Flood Control Project Maintenance
Levee Inspections

Maintenance Issue Types Only, Levee Inspection Report By Mile - Fall 2018

Levee District No. 0003 (Glenn County)

Waterway	Bank	Unit Miles	Inspection Start/End	Inspector
Unit No. 01 Glenn County Sacramento River	Left	11.97	09/06/2018 09/06/2018	Bob Duffey

Photo 1 of 1 : FA_2018_LD0003_27_35_20180905_00019.jpg

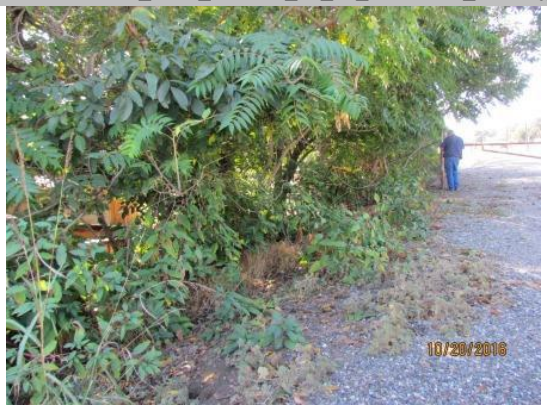
LM Start	**6.75**	Rating **	M	Issue No.	**35**
LM End	**6.75**	Issue Type +	Ma	Location *	LS
Category	Earthen Levee			GPS Latitude/Longitude	
				Start	End
Item	Trim / Thin Trees			39.465013 °	39.465013 °
				-121.991455 °	-121.991455 °
DWR ID	DWR_LD0003_01_s _ 2012_35

T1 : Trim trees to at least five feet above ground level.

View of the trees that are hanging over the landside slope of the levee.

Photo 1 of 1 : FA_2018_LD0003_27_14_20180905_00012.jpg

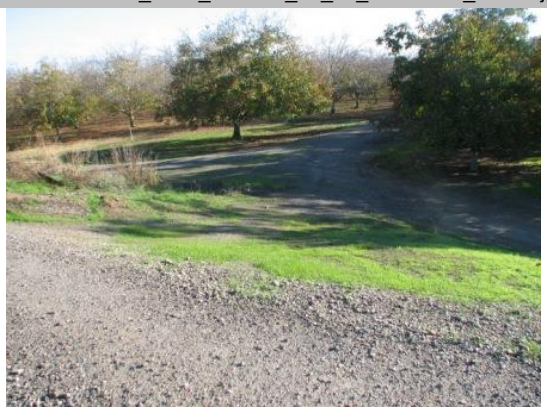
LM Start	**7.21**	Rating **	M	Issue No.	**14**
LM End	**7.21**	Issue Type +	Ma	Location *	LS
Category	Earthen Levee			GPS Latitude/Longitude	
				Start	End
Item	Slope Stability			39.471658 °	39.471658 °
				-121.991245 °	-121.991245 °
DWR ID	DWR_LD0003_01_s _ 2012_14

S3 : Repair the levee slope damaged by vehicle traffic and prevent access where possible.

View of the vehicle erosion along the landside slope.

Photo 1 of 1 : FA_2018_LD0003_27_5_20180905_00003.jpg

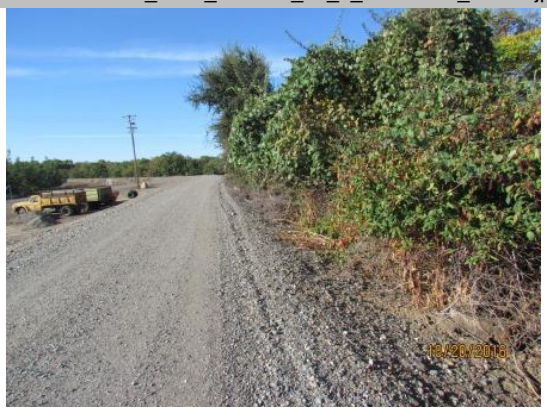
LM Start	**10.14**	Rating **	M	Issue No.	**5**
LM End	**10.24**	Issue Type +	Ma	Location *	WS
Category	Earthen Levee			GPS Latitude/Longitude	
				Start	End
Item	Trim / Thin Trees			39.511788 °	39.512395 °
				-121.983750 °	-121.981975 °
DWR ID	DWR_LD0003_01_s _ 2012_5

T2 : Thin trees to allow visibility of the ground and room to flood fight.

View of the dense vegetation along the waterside slope.
